**Wisconsin Electric** POWER COMPANY  
231 W. MICHIGAN, P.O. BOX 2046, MILWAUKEE, WI 53201

DOCKET NOS. 50-266 AND 50-301  
SUBMITTAL OF QUALITY ASSURANCE PROGRAM DESCRIPTION  
POINT BEACH NUCLEAR PLANT, UNITS 1 AND 2

In accordance with the requirements of 10CFR50.54(a)(2), we are submitting the latest revision of Section 1.8 of our Final Safety Analysis Report which describes the Quality Assurance Program being implemented at Point Beach Nuclear Plant.

TABLE 1.8-3

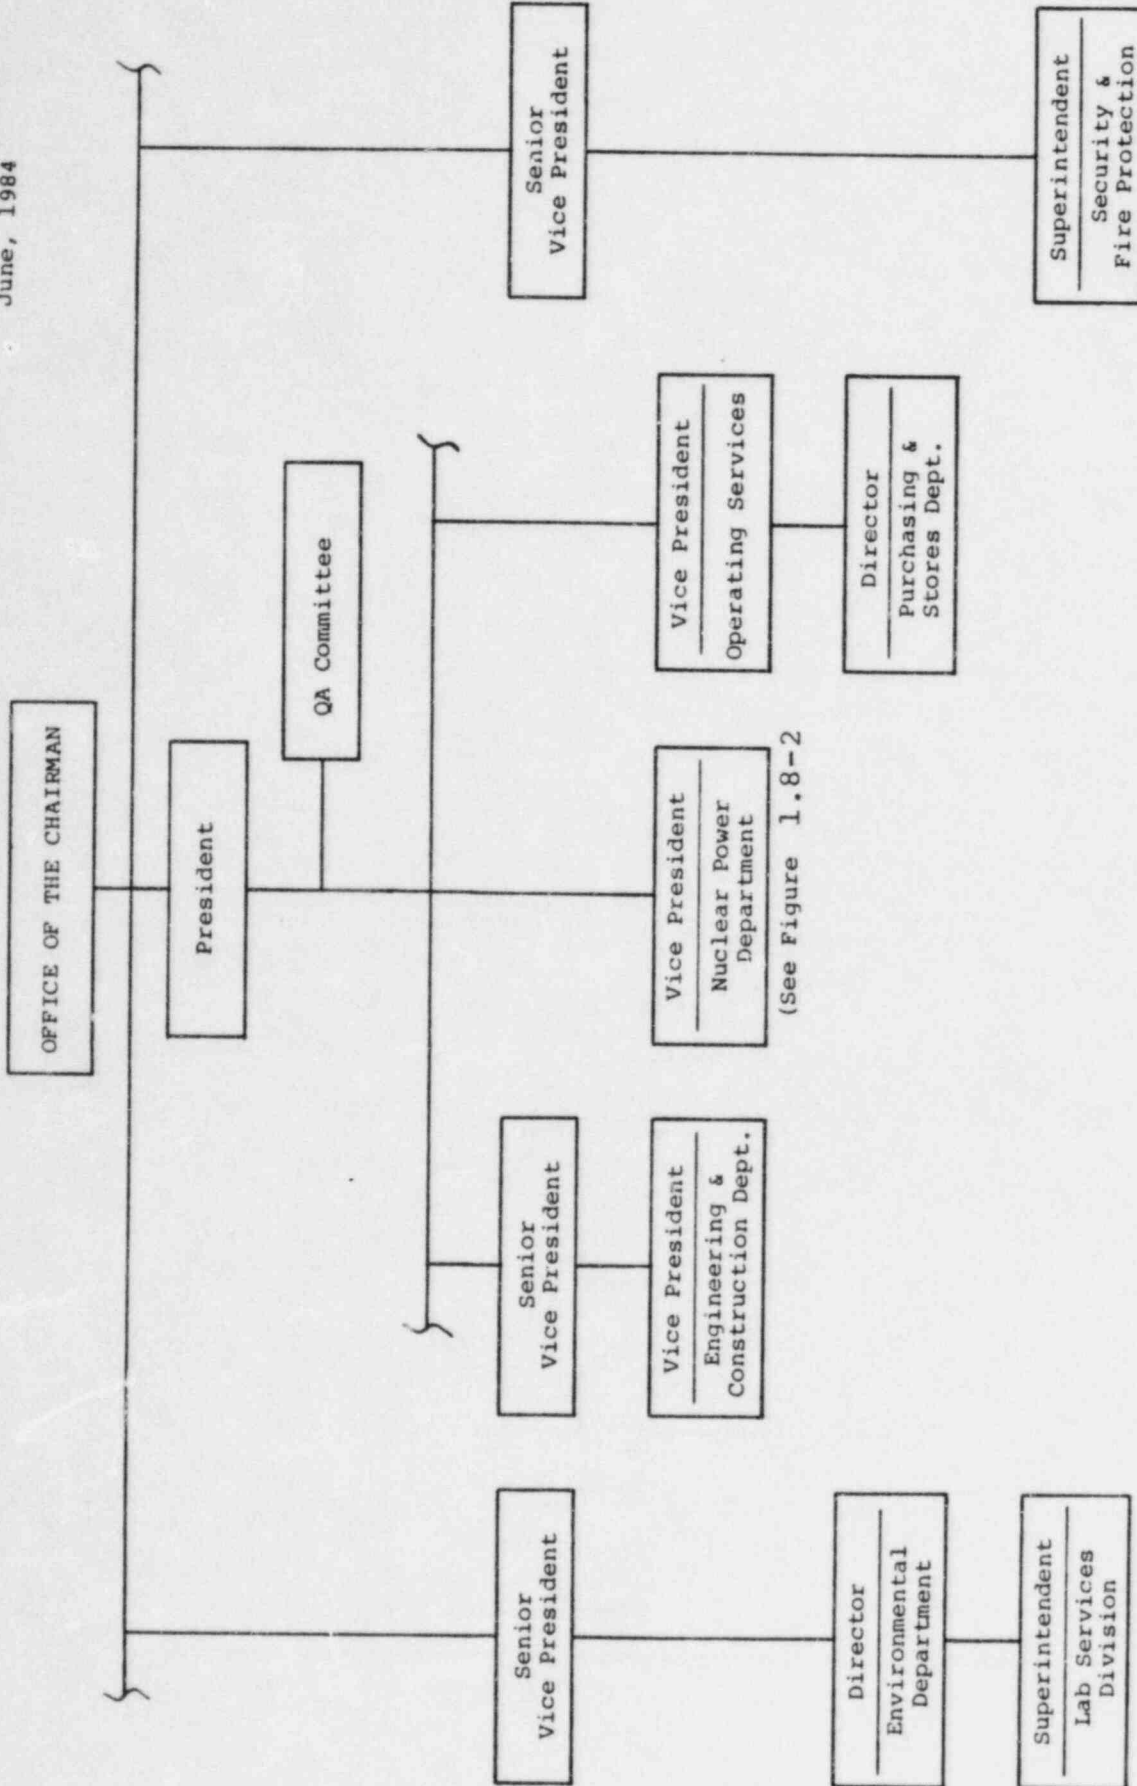
30. Page 1.8-21, Paragraph 5 - See item I.14 above for explanation of description changes.
31. Page 1.8-22, Paragraph 3 - See item I.15 above for explanation of changes. Also reflects changes in organizational title.
32. Page 1.8-22, Paragraph 4 - Changed word "data" to "results" for clarity.
33. Table 1.8-3 - Same explanation as item II.2 above.

Figure 1.8-2 NUCLEAR POWER DEPARTMENT ORGANIZATION

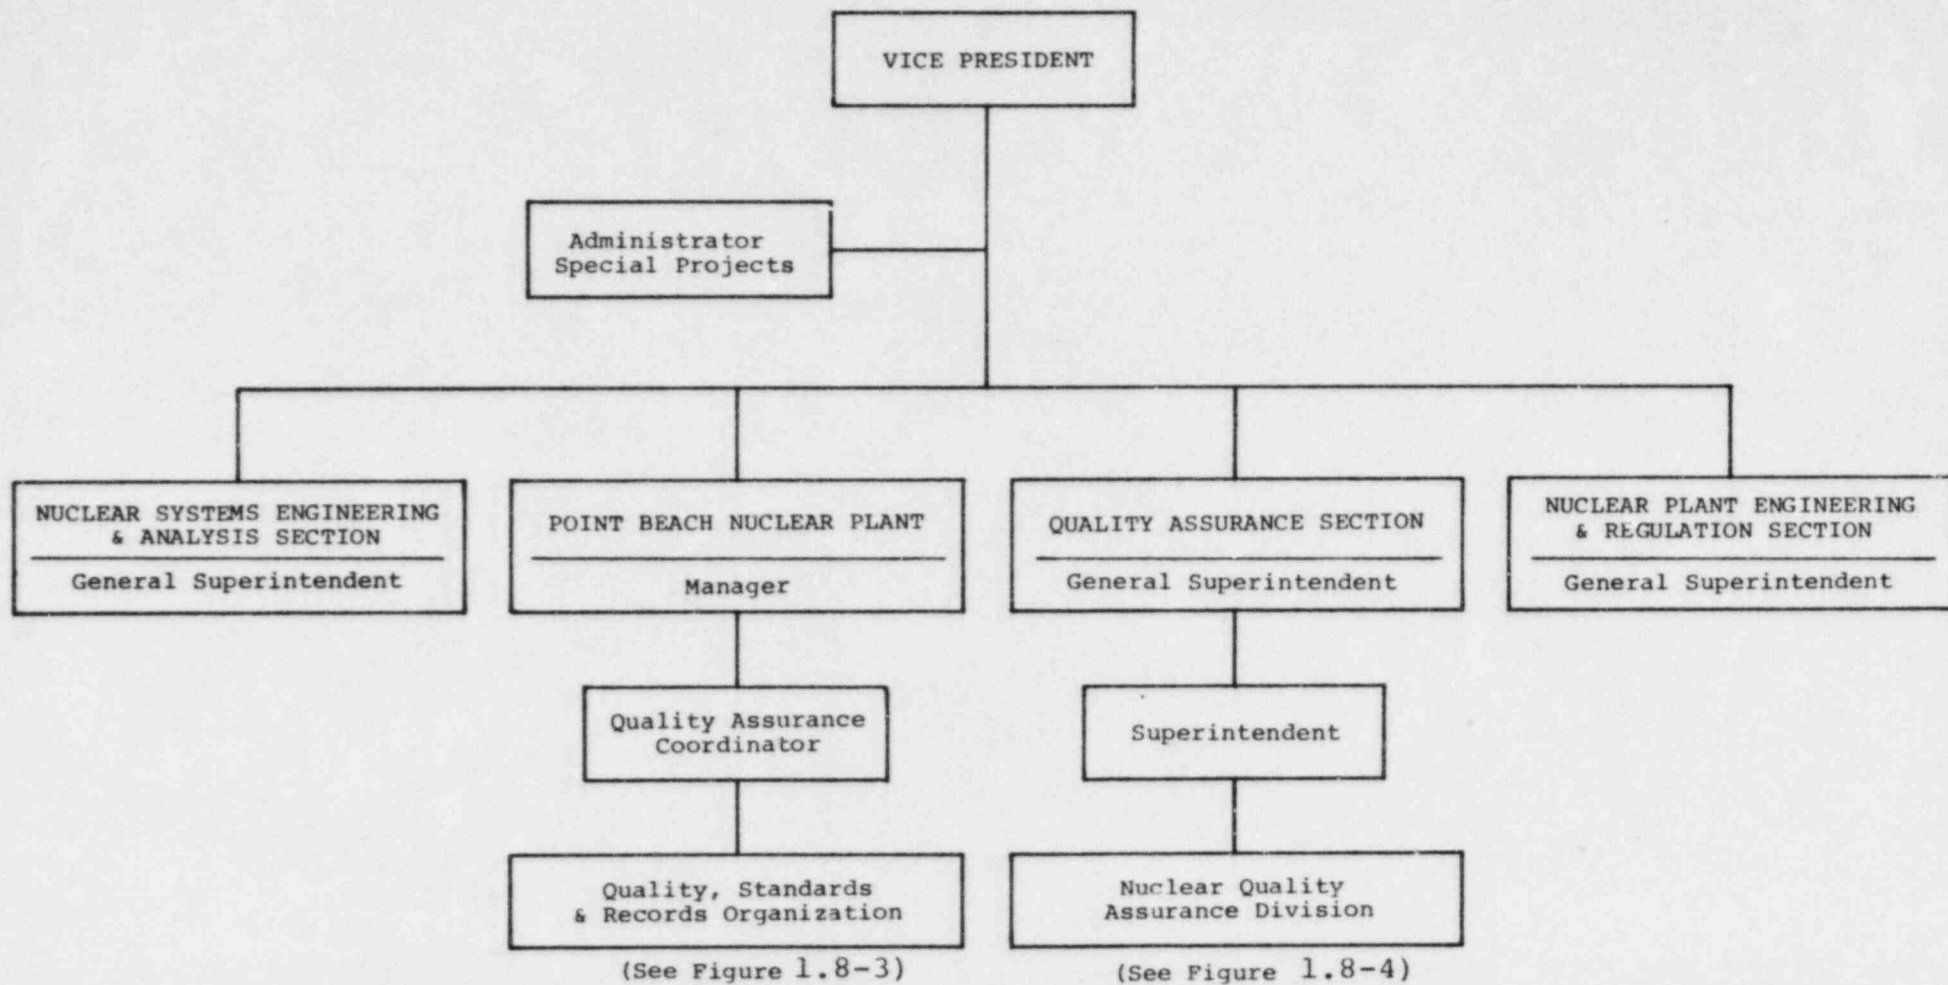
1. General - On two occasions since our last submittal, changes have been made in the Company and Nuclear Power Department organizations as depicted in Figures 1.8-1 through 1.8-4:
  - a. On January 1, 1984 the Nuclear Engineering Section was split into two sections: Nuclear Systems Engineering and Analysis Section and Nuclear Plant Engineering & Regulation Section. Each section is headed by a General Superintendent. Also at this time the Superintendent of QA became the General Superintendent of the QA Section (Figures 1.8-2 and 1.8-4).
  - b. Effective May 9, 1984, the Vice President - Nuclear Power Department now reports to the President (Figure 1.8-1).

The organizational and title changes are reflected throughout Section 1.8 as part of this revision. None of these changes effect our quality assurance commitments since the authority and independence of the Vice President-NPD and the Quality Assurance organization is not reduced.
